## **Advisory Notice for Titan T-51 Mustang Aircraft**

July 7, 2010

### **Inspection required before any further flights**

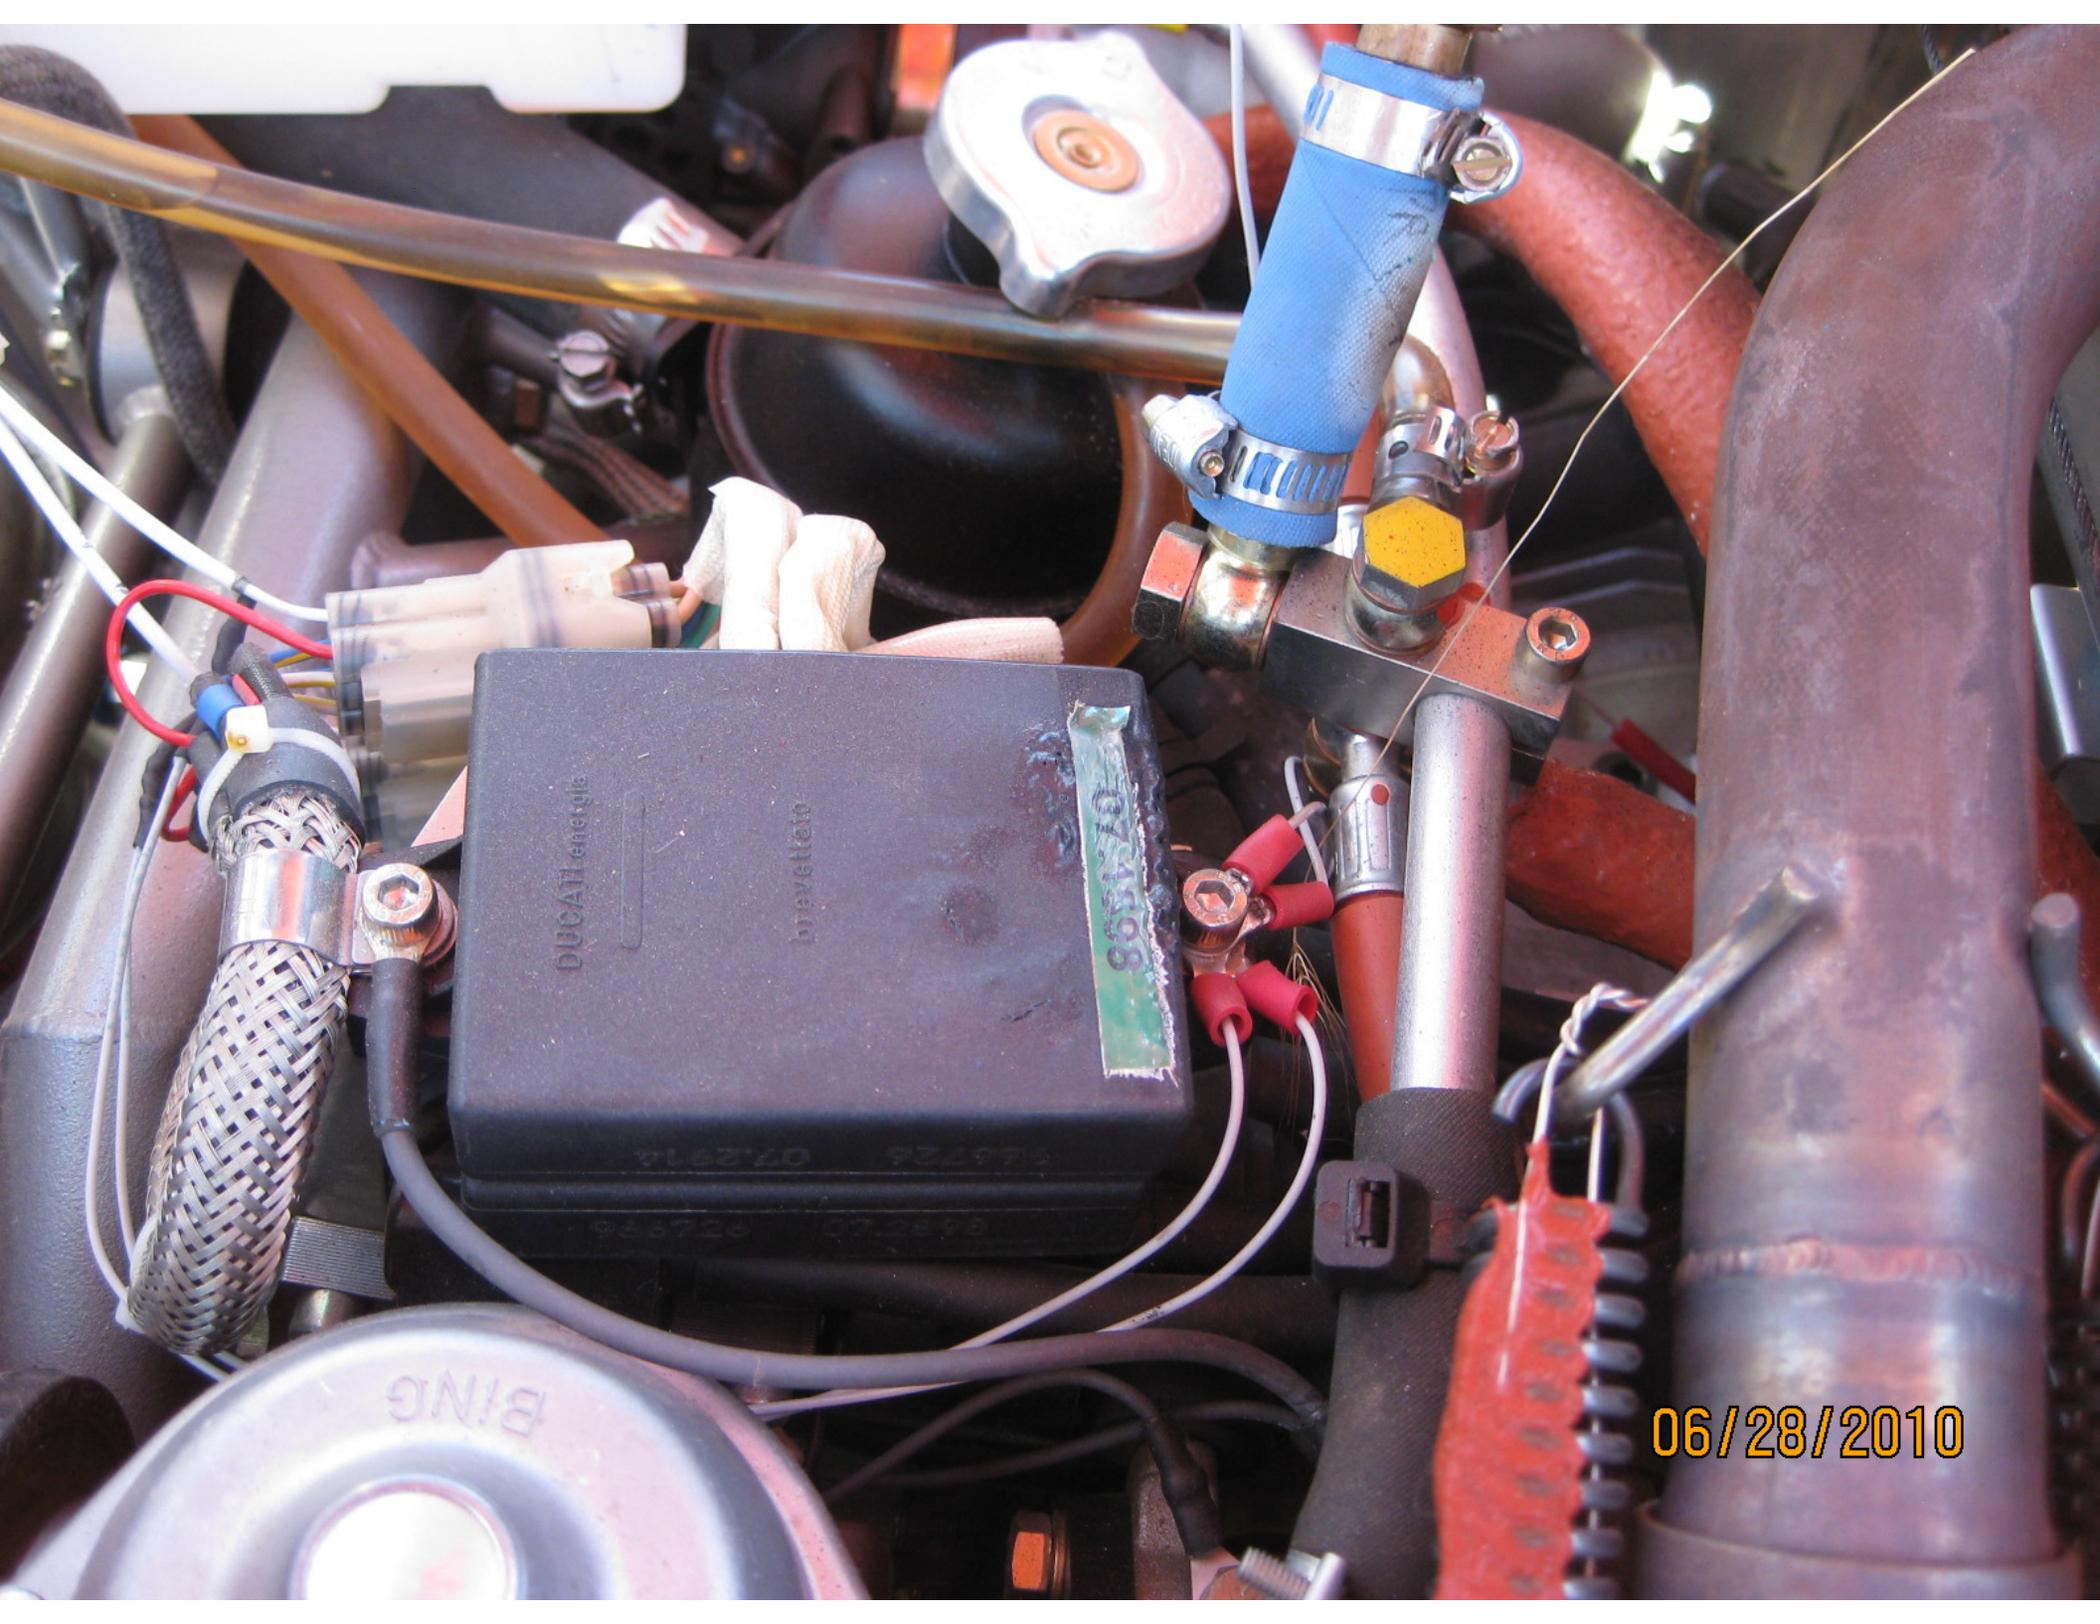
Ignition module failure can occur due to heat from the exhaust.

With the cowlings removed, closely inspect the ignition module and surrounding area for discoloration and/or melting of the plastic housing and wires.

Please see attached pictures for reference.

Installation of exhaust/header wrap on the muffler and outlet pipes or fabrication of a heat shield to cover the ignition module is required.

The exhaust/header wrap can be purchased from any store that sells automotive performance parts. As a reference, this part number: THE-11002, is available at Summit Racing.

The heat shield can be constructed from stainless steel or aluminum. Note that the shield will have to be inspected regularly and replaced if it begins to crack.
